# Access Compliance Report

## Public Rights-of-Way

Intersection ID: 43309	Main Street: ALLENWOOD_RD	Cross Street: FALLS_LAKE_DR	Location: W
ADA ID: 3721EE3ED409	Ramp Type: PerpDiag	Initial Pass/Fail: Fail	Overall Compliance: No
Codes/Mitigation Info/Possible Solution		Field Measurements/Component Compliance

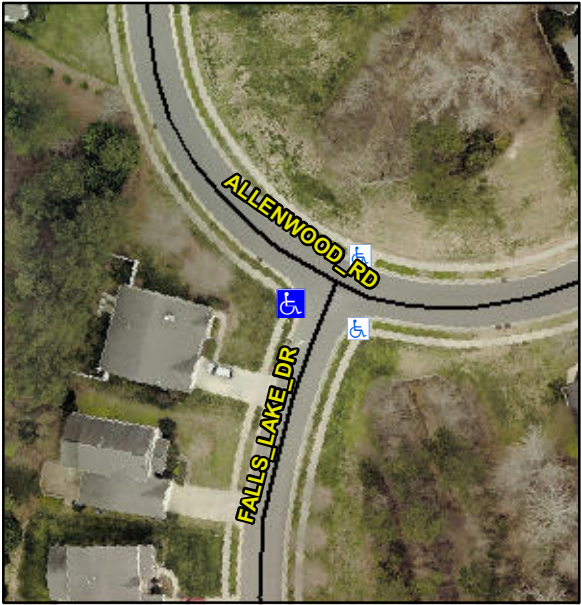
Possible Solutions:	Compliance	Description	Data	Compliance	Description	Data
	Remove & Replace Curb Ramp With Two New Directional Ramps or Equivalent.	N/A	Ramp Length (in)	47.5	No	Ramp Slope (%)	10.7
<p>Surveyor Notes:</p> <p>N/A</p> <p>PROW/ADA:</p> <p>Not Found, R304.5.1, R304.2.2</p>		No	Ramp Width (in)	38.0	Yes	Ramp XSlope (%)	1.1
		N/A	Flare Type LT	N/A	N/A	Flare Type RT	N/A
		N/A	Flare Slope LT (%)	N/A	N/A	Flare Slope RT (%)	N/A
		N/A	Flare Traversable LT?	N/A	N/A	Flare Traversable RT?	N/A
		N/A	Landing Length (in)	N/A	N/A	DWS Provided?	N/A
		N/A	Landing Width (in)	N/A	N/A	DWS Contrast?	N/A
		N/A	Landing Slope (%)	N/A	N/A	DWS Length (in)	N/A
		N/A	Landing X Slope (%)	N/A	N/A	DWS Full Width?	N/A
		N/A	Landing Curb? (Y/N)	N/A	N/A	DWS Offset (in)	N/A
		N/A	Shared Landing?	N/A			
		N/A	Gutter Ponding?	N/A	N/A	Gutter Slope (%)	N/A
		N/A	Gutter Lip Ht (in)	N/A	N/A	Gutter X Slope (%)	N/A
		N/A	Painted X Walk1?	No	N/A	Painted X Walk2?	No
